From: James Snelgar [REDACTED]
Sent: 23 September 2021 17:23
To: Simon Davis
Subject: FW: Yapton
Attachments: YAP-130-026J Pervious System Network Layout_70 Units.pdf

From: Arek Kadlec <[REDACTED]>
Sent: 16 September 2021 12:19
To: Laura Gibbons <Laura.Gibbons@arun.gov.uk>

Please find attached revised drawing that shows thicknesses of sub-base across the site.

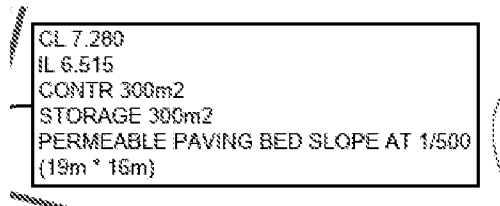
3. The summary boxes of the permeable paving areas (example snapshot below) refer to the cover level and invert level for a 'spot location' (i.e. downstream end of the permeable paving modelled section) – therefore previous comment of single *minimum sub-base thickness* (i.e. being 555mm for paving section 26) is not entirely representative for Type 6A areas
